## ST75C520 REVISION 1.4

## I - INTRODUCTION

The purpose of this document is helping the customer to use the Revision 1.4 of the ST75C520. So the ST75C520 Revision 1.4 Application Guide answers some questions as :

**Figure 1 : Detailed Timing Diagram**

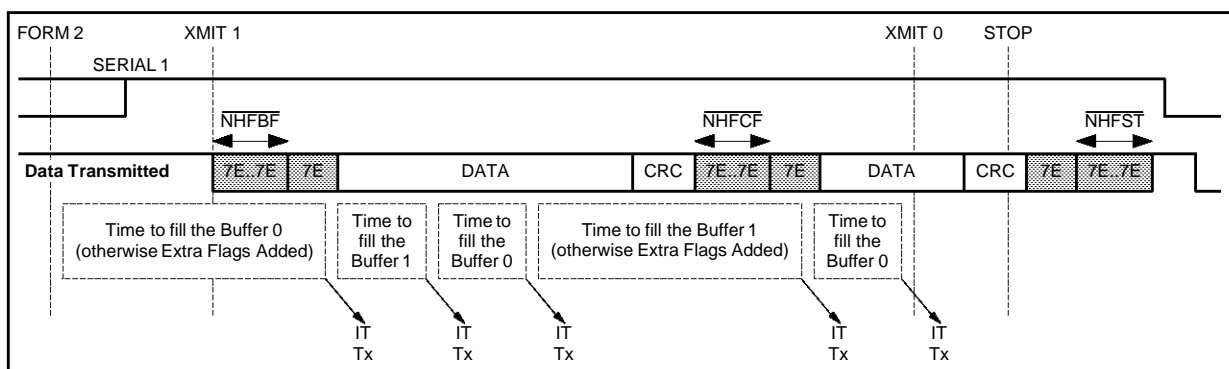
Three new global variables have been added in the Revision 1.3 to allow the programming of new 7E flags before the first frame, between the data frames and after the last frame :

- `_NHFBF`: Number of flags before the first frame.
- `_NHFCF`: Number of flags between frames.
- `_NHFST`: Number of flags after the last frame.

The default value for these three variables is 0. The programming range is from 0 to 7FFF (32767) (see Figure 1).

**Figure 3 : D**

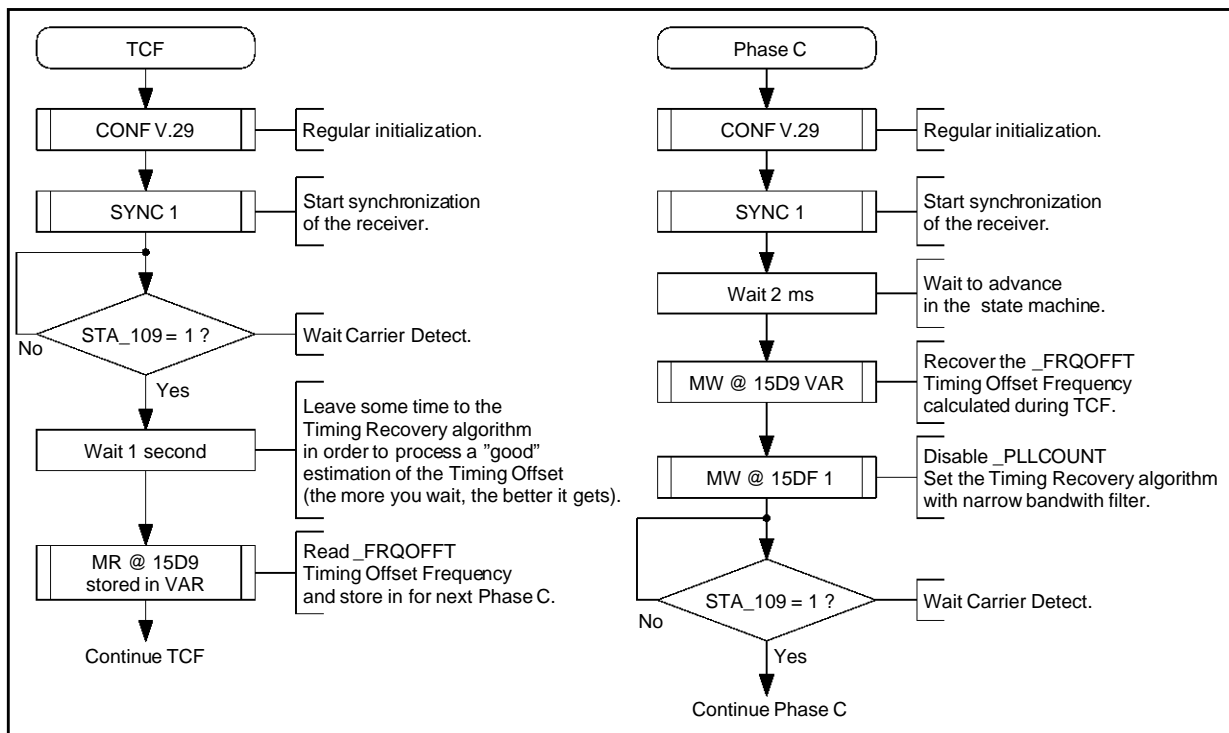
HP5	JAPAN Line patch	Feb 1, 96	Revision 1.2 to 1.4	p19
-----	------------------	-----------	---------------------	-----

The sequence is described in the following flow chart.
